## **ECR related to 120A/200 A HL-LHC circuits**

TCC Meeting, 20/09/2018

# The proposal

120 A Leads (16) + 200 A Leads (2)

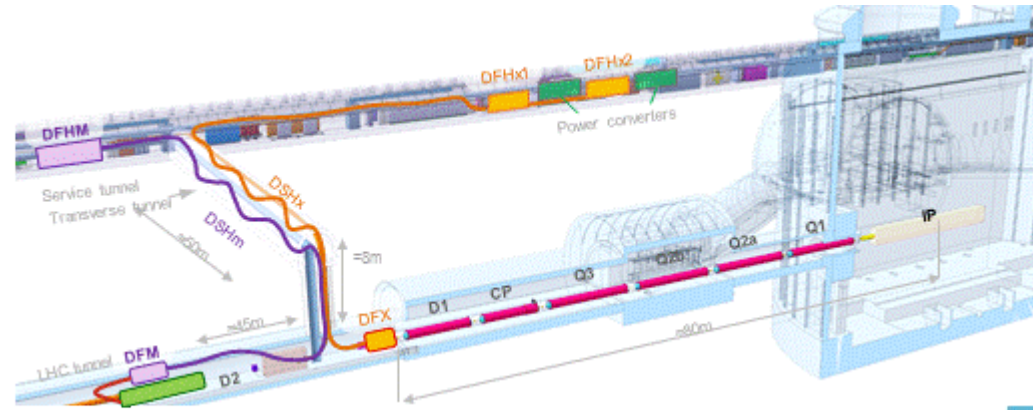
120 A Leads removed from SC Link and locally integrated in the magnets' cryostat  
This is the solution adopted for LHC

- **Elimination** of the about **100 m long electrically insulated MgB<sub>2</sub> cables**, rated for DC currents of 200 A or 120 A, housed inside the superconducting link (eighteen cables per Triplet);

- **Simplification** of the **cabling process** related to the assembly of the 200 A/120 A MgB<sub>2</sub> cables in the final MgB<sub>2</sub> cable assembly;

- **Elimination** of the 200 A/120 A gas **cooled High Temperature Superconducting (HTS) current leads** located in the – replaced by conduction-cooled current leads;

- **Elimination** of the **control valves and warm recovery lines** associated with gas-cooled current leads;
- **Elimination** of the **protection equipment needed for the superconducting part of the circuit, i.e. for the MgB<sub>2</sub> cables and for the HTS part of the leads** (each requiring dedicated protection with different voltage thresholds);

- **Reduction of the number of the electrical splices** in the Cold Powering System, i.e. elimination - per Triplet- of eighteen HTS to MgB<sub>2</sub> splices in the DFH cryostat and eighteen MgB<sub>2</sub> to Nb-Ti splices in the DFX cryostat;

- **Simplification of DFH cryostat** by reduction of number of HTS cables routed out of it and of number of splices it shall host.
- Simplification of the **plug** in the DFX cryostat.
